Platt Technical High School

ADDENDUM NO. 4

August 9, 2019

drawing S1-1-MF

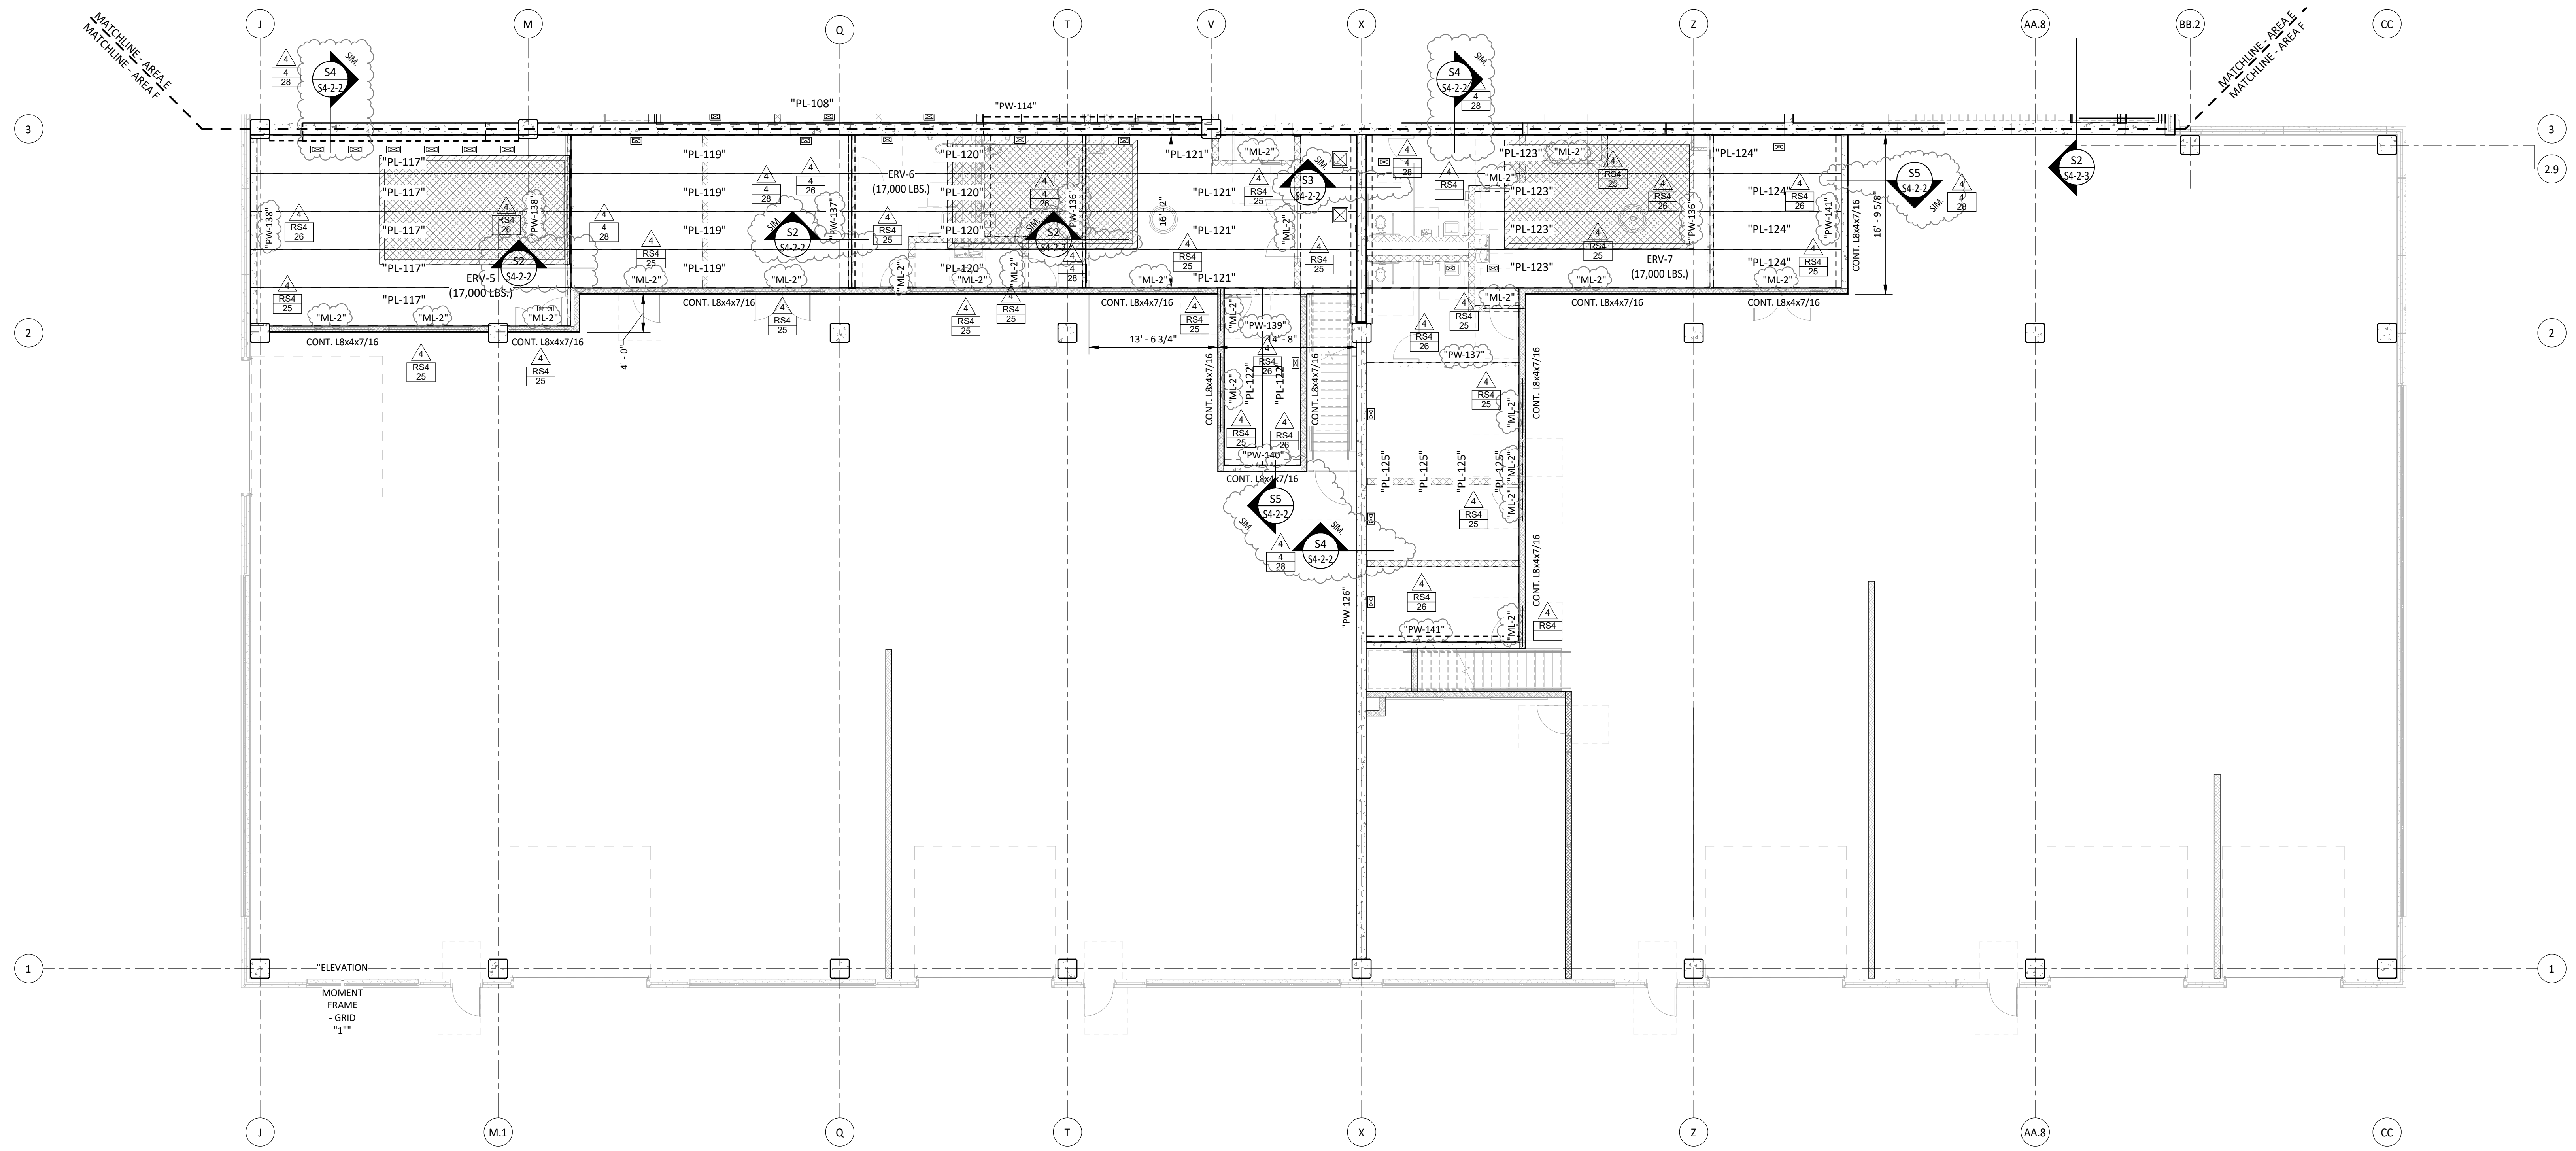
- ADD 4-118 DRAWING S1-1-MF – MEZZANINE FRAMING PLAN – AREA F**
Revised masonry lintels per Revision RS4-25.
Added mezzanine precast wall designations per Revision RS4-26.
Revised plan note #4 per Revision RS4-27.
Added section designations per Revision RS4-28.
